January 4, 2015

RE: El Paso Mexican Restaurant – Drainage Impact Analysis and Plan Review No. 2

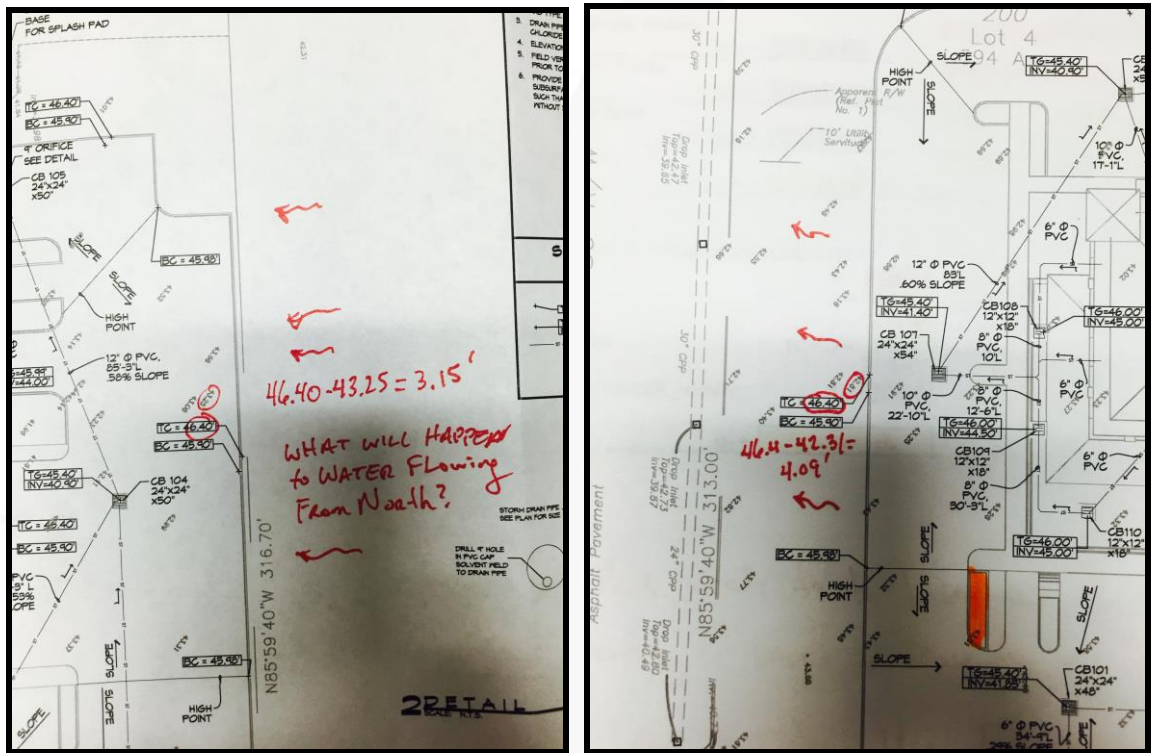
9. The below images illustrate the difference in elevation between the proposed parking lot and the finished grade. The image on the left illustrates the northern edge of the parking lot on the property boundary and a 3.15' elevation difference with the adjacent property. Please discuss how this will impact the drainage of the neighboring property and how it will be constructed on the property boundary as shown. The image on the right illustrates the southern edge of the parking lot and a 4.09' elevation difference between the top of the curb and the natural ground. Please discuss how the grassy area south and west of the development will drain and if it requires its own drainage basin.
